DOCUMENT 00 91 00
ADDENDA
ADDENDUM NUMBER TWO (002)

DATE: May 30, 2025

PROJECT: **Caribou Police Facility**

PROJECT NUMBER: Artifex Project No. 2023102

ADD. 2
SK001

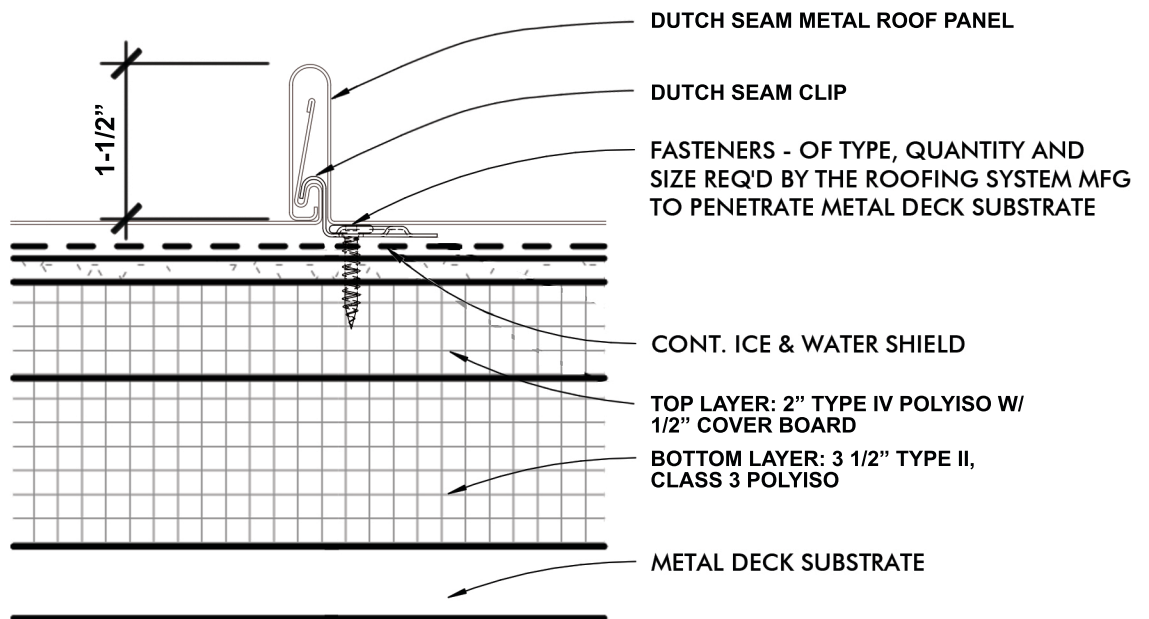
2.05 Question: Standing Seam Panel Specification:

The specification section for standing seam metal roofing lists only a 1.5" snap-lock panel. Is this specification intended solely for the RA2 assembly? If not, a separate spec section for a 2" standing seam metal panel may be required for RA1 and RA1a.

5.01 Replace RA1 on Sheet A500 with attached SK001

Answer: The attached drawing ADD.2 SK001 is a replacement for RA1 on sheet A500. Exterior roofing will be the 1 1/2" ATAS (or equal) Dutch seam metal roof. We are also using the same material (different color) as siding.
